Citrus County Central Landfill

Phase 1 Operating Permit Renewal Pending Permit Number.: SO09-274381

Your requests for additional information from your August 15, 1995 letter are restated below with our response.

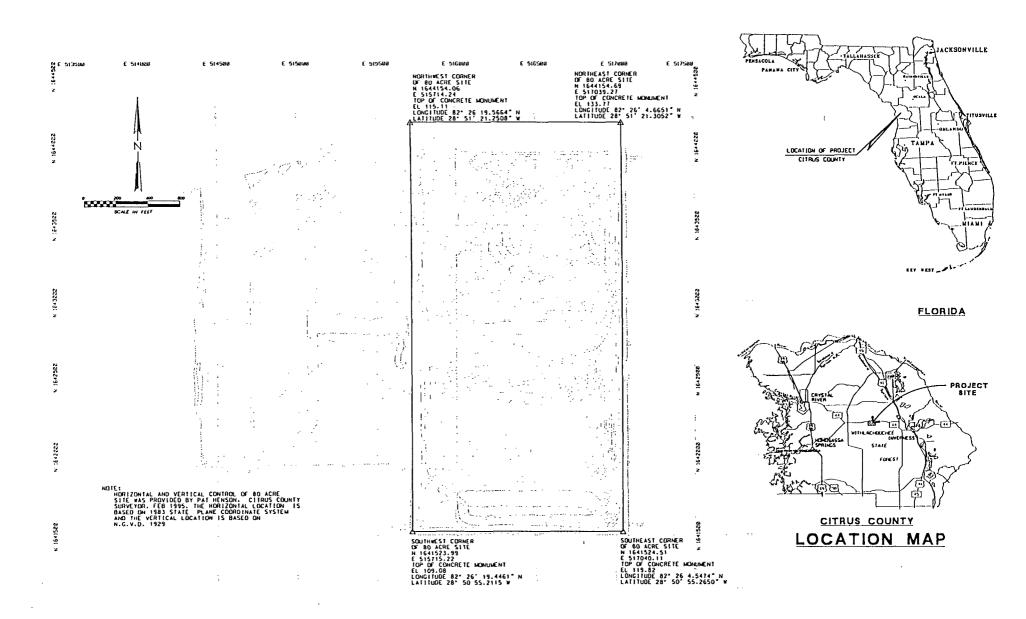
**Request No. 3** Item D.14. Please provide confirmation from DOT that there are no airports within five miles of the landfill.

**Response No. 3** Confirmation from the Florida Department of Transportation (FDOT) that there are no airports within five miles of the landfill is provided in Attachment D to this correspondence

Per your attached letter request, this GIS Map shows there are no public airports within 5 nm of the County's Central Landfill and only one private facility, Ringhaver which is a helistop. This facility does not have a "runway licensed by the state" as provided in 62-710, therefore it does not need to be considered for the planned expansion. There are no airport facilities within 10,000 feet of the landfill.
